December 13, 1983
IPN-83-99

Subject: Indian Point 3 Nuclear Power Plant
Docket No. 50-286
Appendix R Fire Protection Program

Attachment A to IPN-83-99

APPENDIX "R" MODIFICATION USING DIESEL GENERATOR NO. 31 AS POWER SOURCE

ISSUE PRELIMINARY						ENGINEER	
5/2/83	\$	N				STATE REG.	NO.
DATE	DWYBY	CHRYBY	DS	DAE	PROJ ENJ MGR	INDIAN POINT GENERATING STATION UNIT NO 3	
			DE	DD		DWG NO.	REV. PI
						FIGURE A	SHT. - OF -

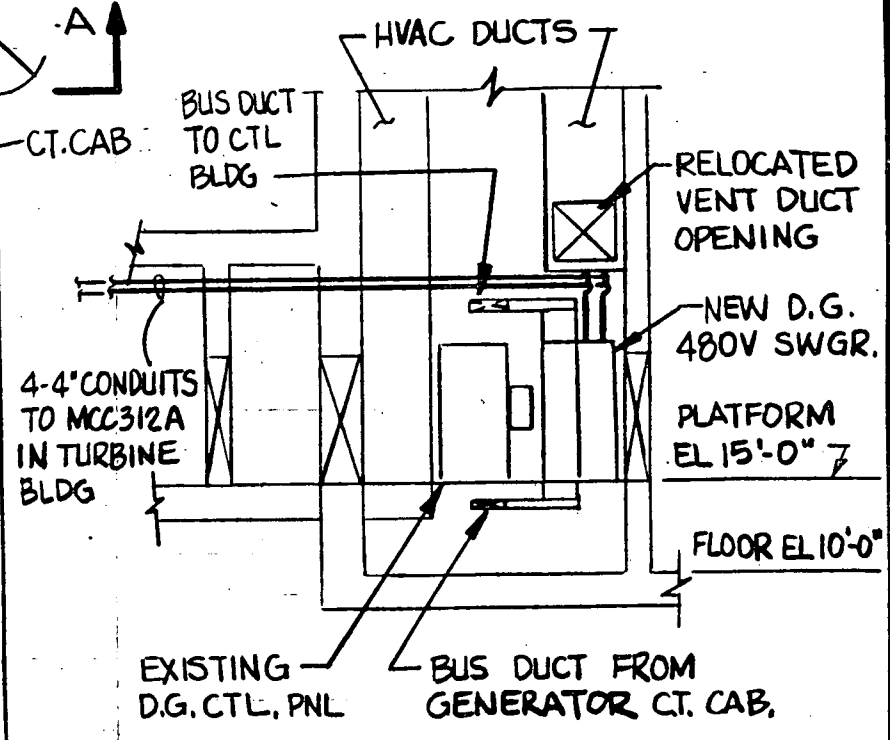
The Authority's aforementioned May 20, 1983 letter informed the NRC that the Authority was then considering three options for assuring availability of an on-site power supply for safe shutdown equipment given a hypothetical fire scenario adversely affecting selected areas of the plant. The Authority is planning to provide said power supply from existing emergency diesel generator no. 31, via new 480 volt switchgear, to motor control center 312A in the turbine building. Preliminary sketches of the proposed modification are shown in Figures A and B included in the Attachment to this letter. The Authority is proceeding towards completion of these modifications prior to startup from the next (cycle 4/5) refueling outage.

ENGINEER	STATE REG.	NO.
INDIAN POINT GENERATION STATION UNIT NO.3	M	
DWG. NO.	REV. PI	SHT. - OF -
FIGURE B

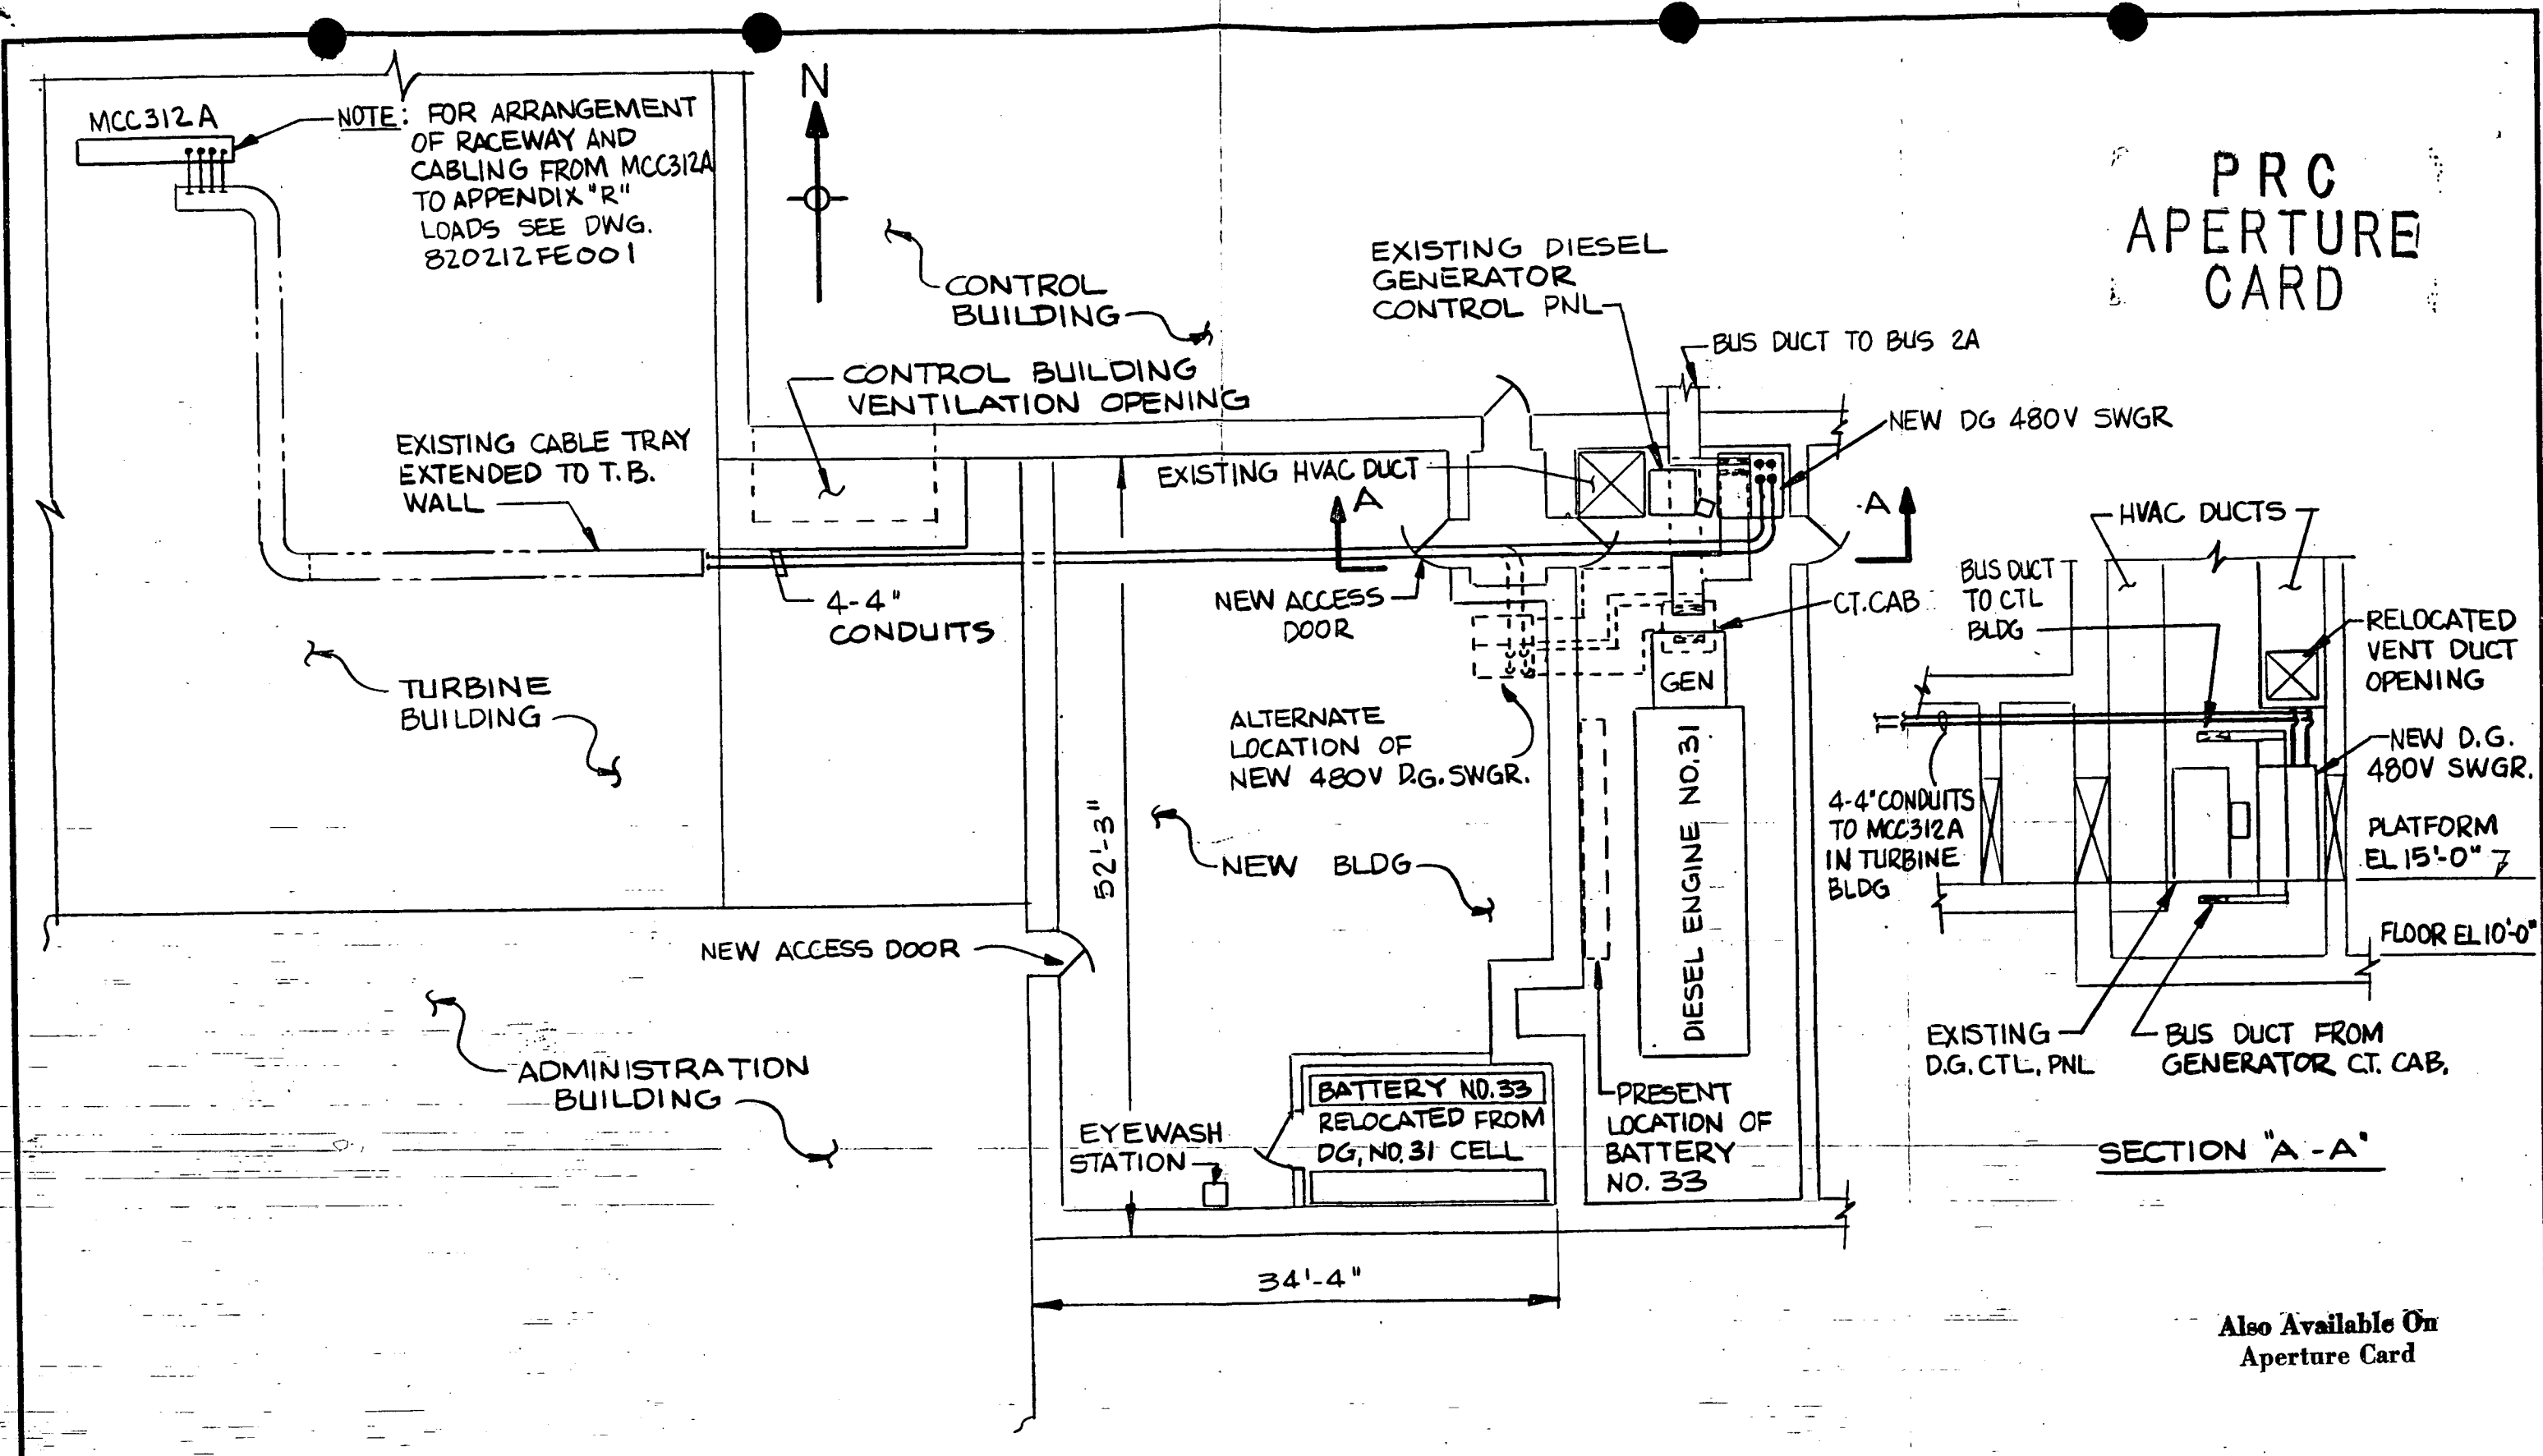
APPENDIX "R" MODIFICATION USING DIESEL GENERATOR NO.31 AS POWER SOURCE
